13 August 2008

PROPOSAL FOR DRAFT AMENDMENTS TO REGULATION No. 48
(Installation of lighting and light-signalling devices)

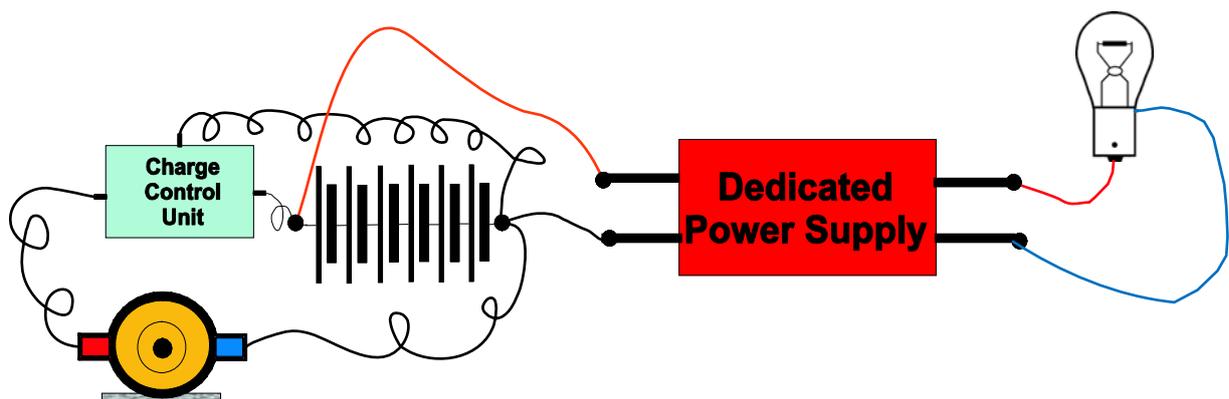
"5.27. The applicant shall demonstrate to the Technical Service responsible for type approval testing that the electric power supply conditions for the devices indicated in 2.7.9, 2.7.10, 2.7.12, 2.7.14 and 2.7.15 above comply, when the electrical system of the vehicle is in a constant voltage operating condition, representative for the relevant category of powered vehicle as specified by the applicant, with the following provisions:

By the fact, that it seems not to be possible to find a common test procedure applicable for the smallest M1 up to the biggest N the discussion in OVIg results in the following way to solve the problem . The technical Service is requested to determine that the electric power supply conditions for the devices comply, when the electrical system of the vehicle is in a constant voltage operating condition, depending of the individual characteristics and means of the electrical power network of the relevant category of powered vehicle as specified by the applicant.

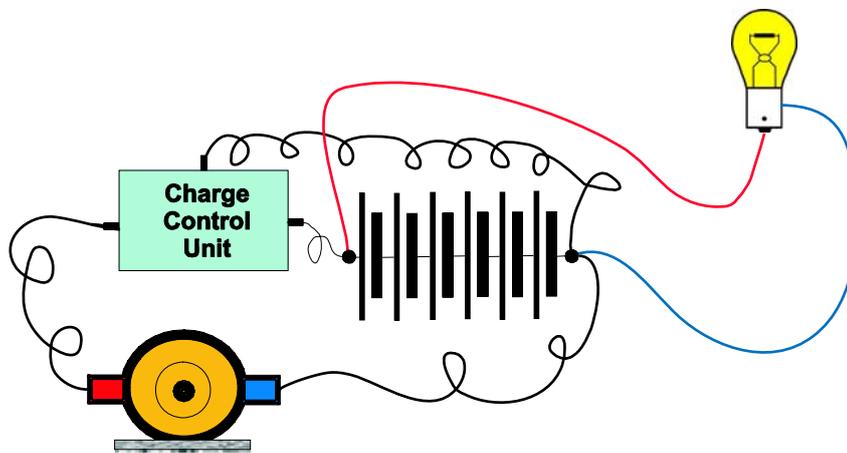
5.27.2. In all cases of electric power supply conditions not covered by paragraph 5.27.1, the voltage at the terminals of the device(s) or function(s) shall not exceed 6.75V (6 Volt-Systems), 13.5V (12 Volt-Systems) or 28.V (24 Volt-Systems) by more than 3%."

This paragraph is exclusively for the conventional vehicle without any electrical power control unit for the voltage, other than the charge control for the battery.

The voltage specifications and their tolerance have to be strictly regarded together with paragraph 5.27 above!

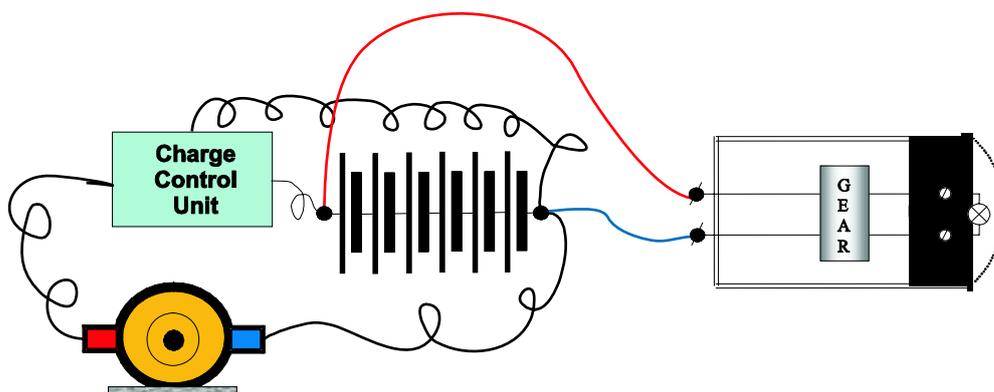
5.27.3. The provisions of paragraphs 5.27.1. and 5.27.2. shall not apply to devices which include an electronic light source control gear or a variable intensity control being part of the device."

This paragraph is exclusively for lighting units with light source control gears, of which the light output is nearly independent from the input voltage at the input terminal of the lamp unit
